DRB RECOMMENDATION MEETING: JUNE 7, 2018

DESIGN REVIEW

SDCI 3024332 - 4800 40th AVE SW

LIVE WORK

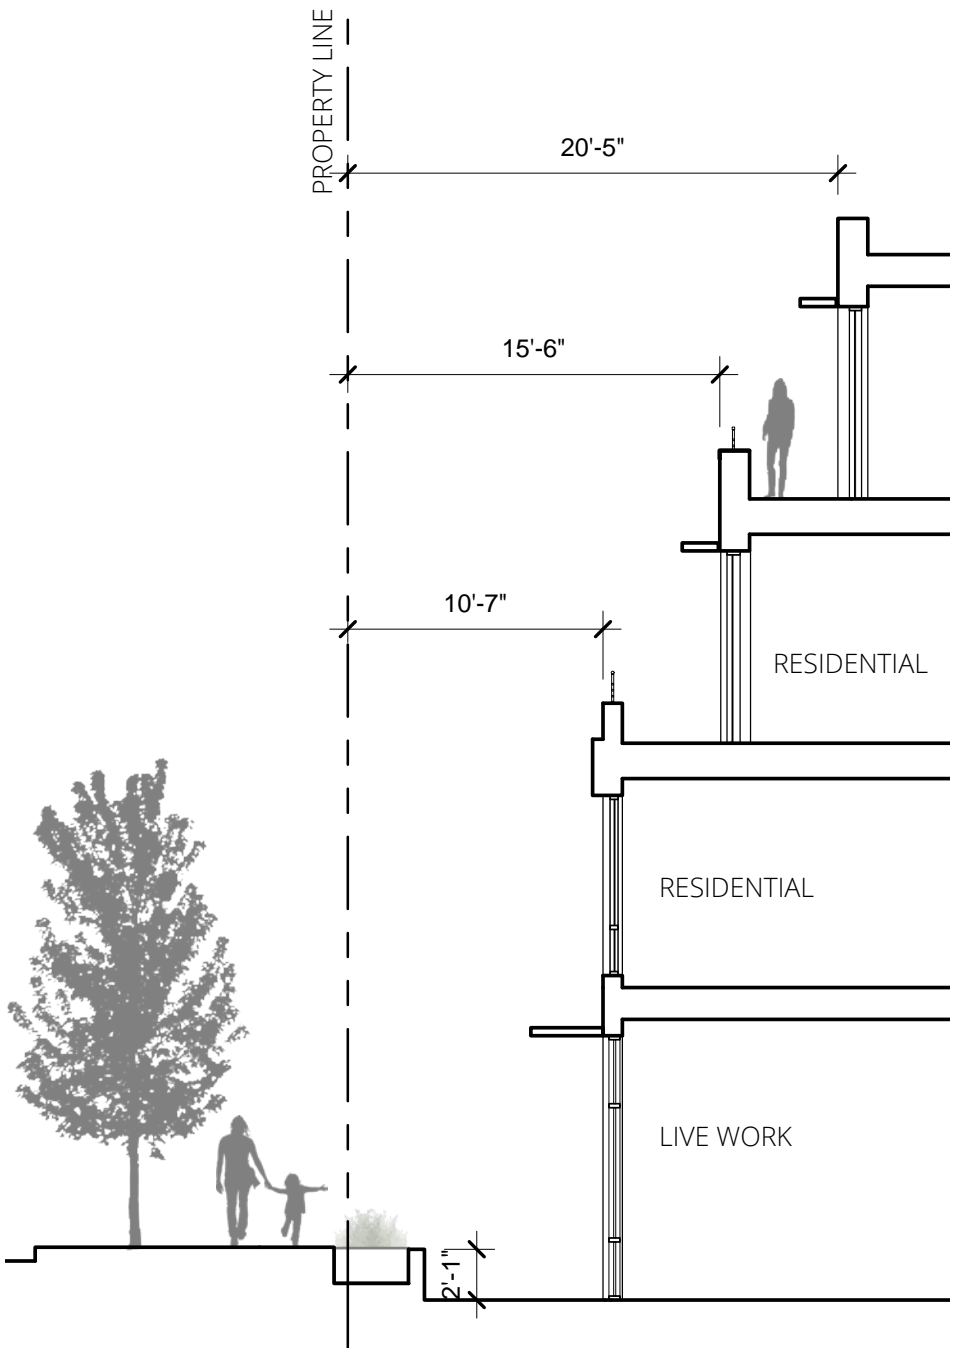
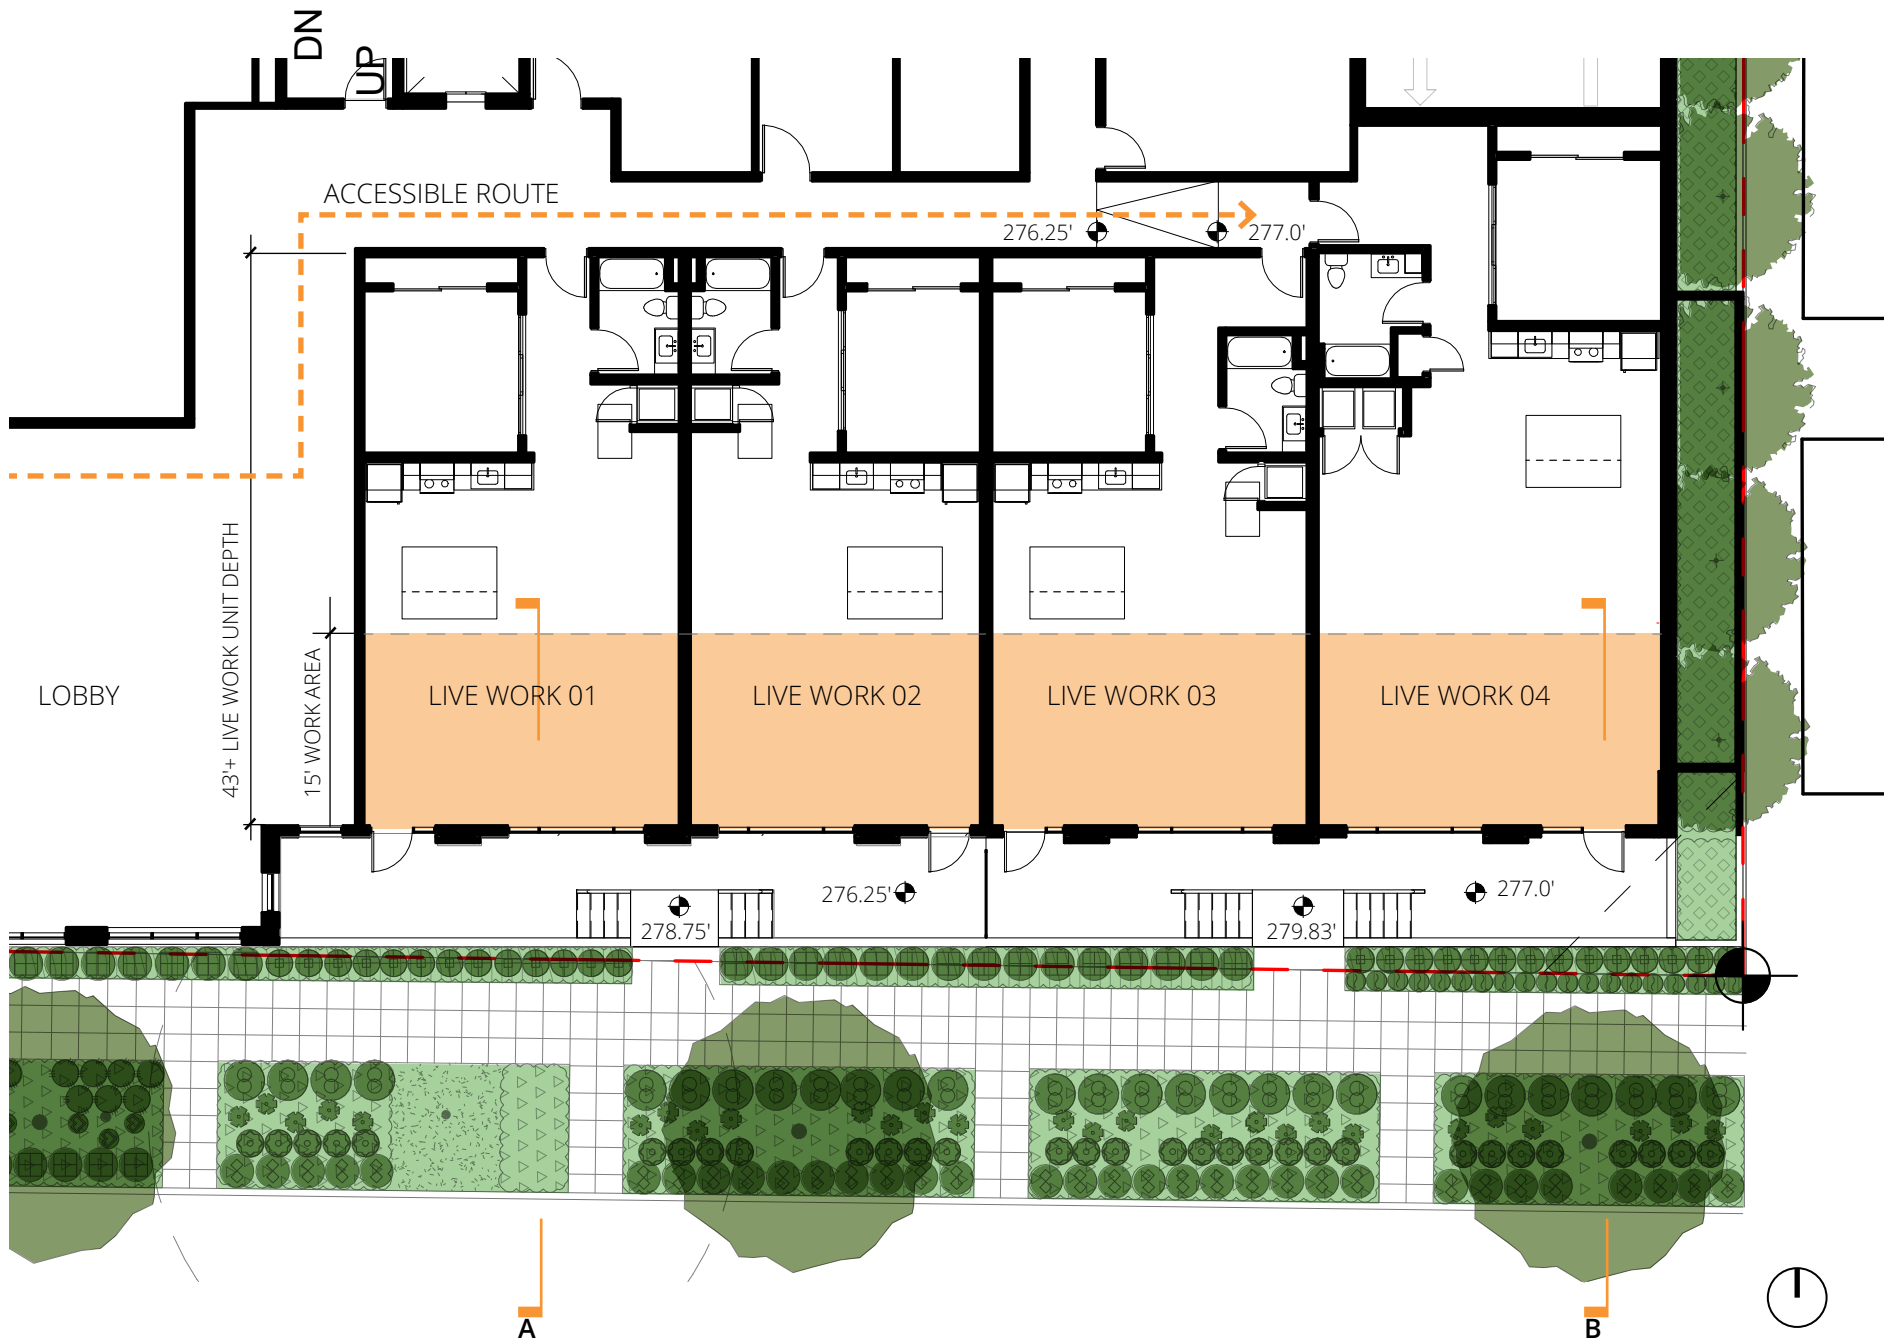
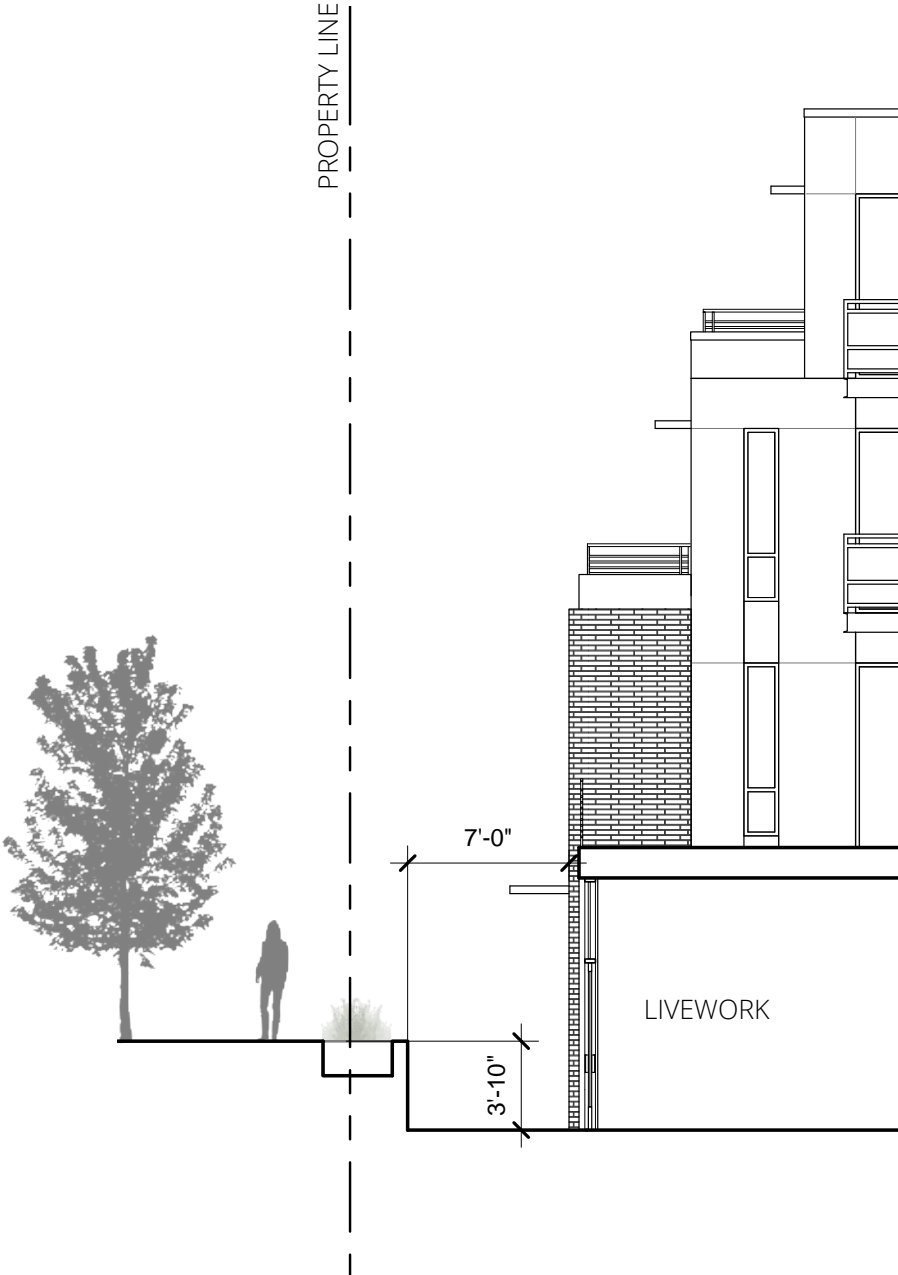
- Information on Interior Programming of Live/Work Units

Much like our approach to the commercial facade along Edmunds, the live work facade along 40th has been designed with a facade articulation what echoes architectural cues taken from successful Junction buildings. The scale here is smaller in scale than that of Edmunds which helps to further break down the scale as we transition to the LR zone.

We have maintained the low planting as a buffer between the public walkway and private unit entries, as suggested by the board. The increase in transparency of the live work bays, provides greater visual connection between the sidewalk and the work zones inside these units, while setting back the facade and entries makes these spaces slightly more private than the commercial spaces along Edmunds.

Inside the units, "work" spaces have been oriented toward the public street with more private "live" spaces pushed further into the building.
